Access Compliance Report Public Rights-of-Way (Curb Ramps)

Main Street: N/A Cross Street: S_GILBERT_ST Location: NW

ADA ID: RPAT211119132118 Ramp Type: Type 7 - Directional 2 Initial Pass/Fail: Pass Overall Compliance: No Severity Score: 4

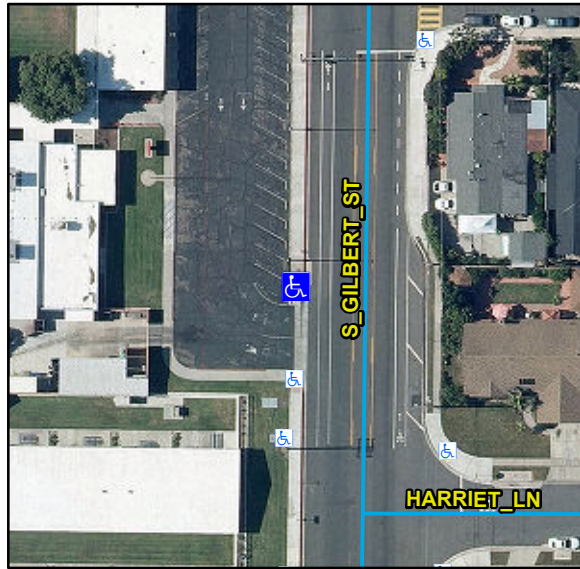
Compliance	Description	Data	Compliance	Description	Data
N/A	Ramp Length (in)	116	Yes	Flare Type LT	Curbed2
Yes	Ramp Width (in)	48			
Yes	Ramp Run Slope (%)	6.7	N/A	Flare Slope LT (%)	N/A
Yes	Ramp Cross Slope (%)	0.9	N/A	Flare Traversable LT	N/A
Yes	Grade Break	Yes	N/A	Flare Type RT	
Yes	Grade Break Slope (%)	1.4			None
Yes	Grade Break Cross Slope (%)	3.3	N/A	Flare Slope RT (%)	N/A
	Addl Para Ramp Left?	No	N/A	Flare Traversable RT	N/A
	Addl Para Ramp Right?	No	Yes	DWS Provided	Yes
N/A	Landing Present	Yes	Yes	DWS Contrast	Yes
No	Landing Length (in)	42	Yes	DWS Length (in)	62
No	Landing Width (in)	42	Yes	DWS Full Width	Yes
Yes	Landing Run Slope (%)	0.1		DWS Offset Type	Single
Yes	Landing Cross Slope (%)	3.3	Yes	DWS Left Offset (in)	0
N/A	Landing Movement Obstructed?	No	N/A	DWS Right Offset (in)	0
	Landing Movement Type	N/A			
N/A	Landing Shared	No			
N/A	Marked Crosswalk 1	No	N/A	Clear Space	N/A
	Crossing 1 Direction	S	N/A	Clear Space To Crosswalk (in)	N/A

Remove & Replace Landing.

R304.2.1, STD 1115
